FORT CALHOUN STATION, UNIT NO. 1

AMENDMENT TO FACILITY OPERATING LICENSE

Amendment No. 133
License No. DPR-40

ATTACHMENT TO LICENSE AMENDMENT NO. 133

FIGURE 2-10

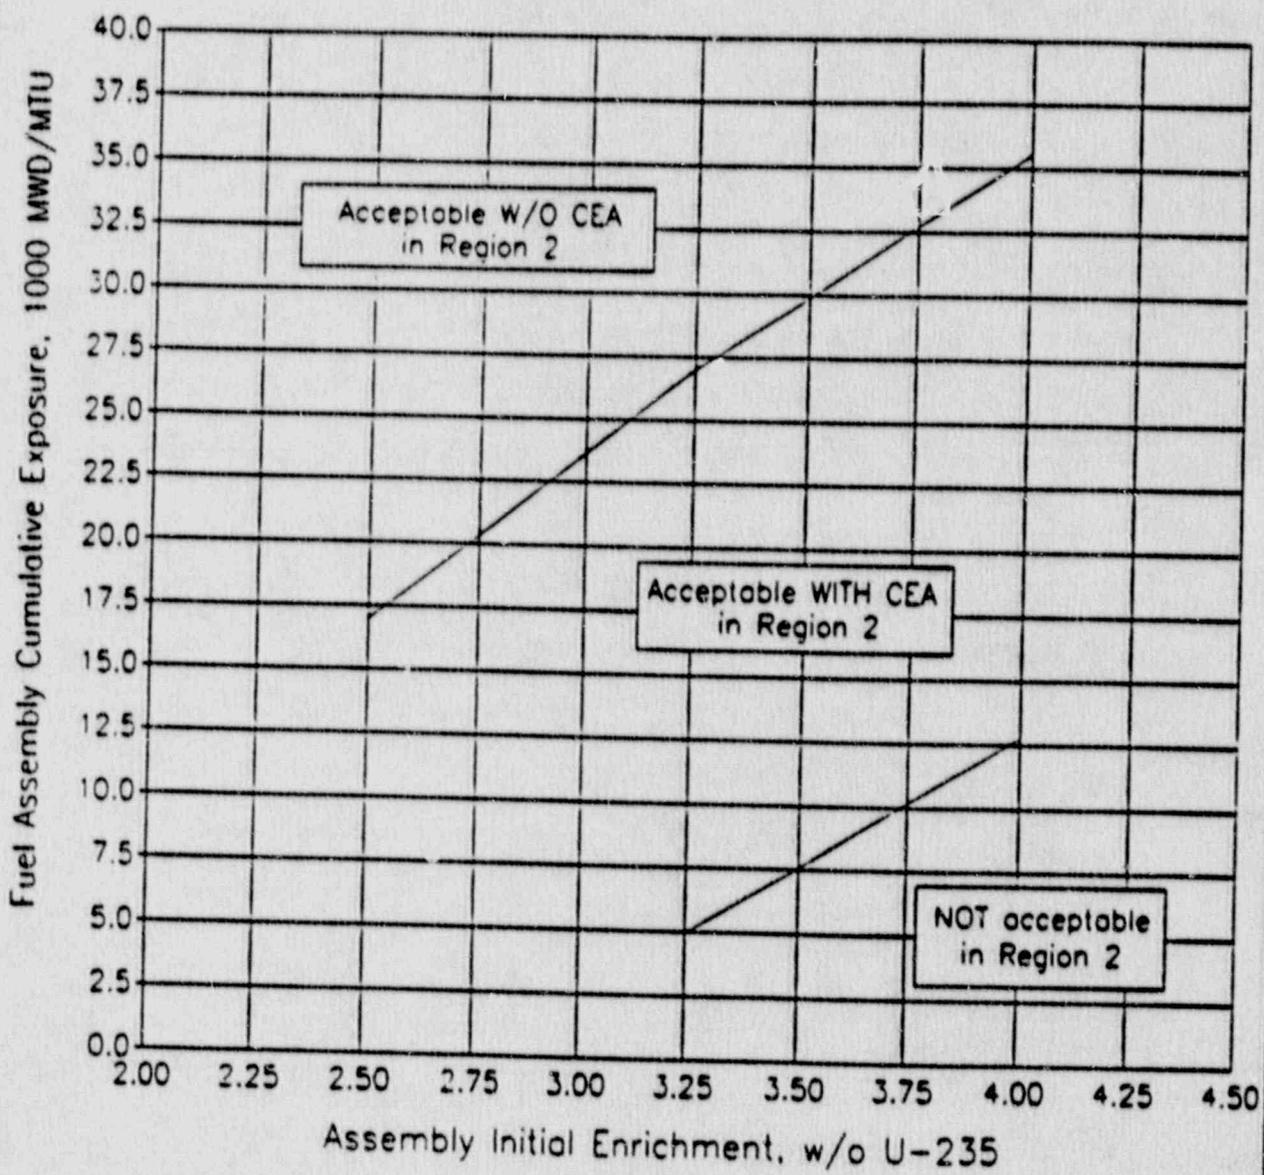
- (11) Storage in Region 2 of the spent fuel racks shall be restricted to those assemblies whose parameters fall within the "acceptable" region of Figure 2-10.

The spent fuel assembly may be transferred directly from the reactor core to the spent fuel pool Region 2 provided the independent verification of assembly burnups as defined in Special Procedure SP-BURNUP-1 has been completed and the assembly burnup meets the acceptance criteria identified in Technical Specification Figure 2-10.
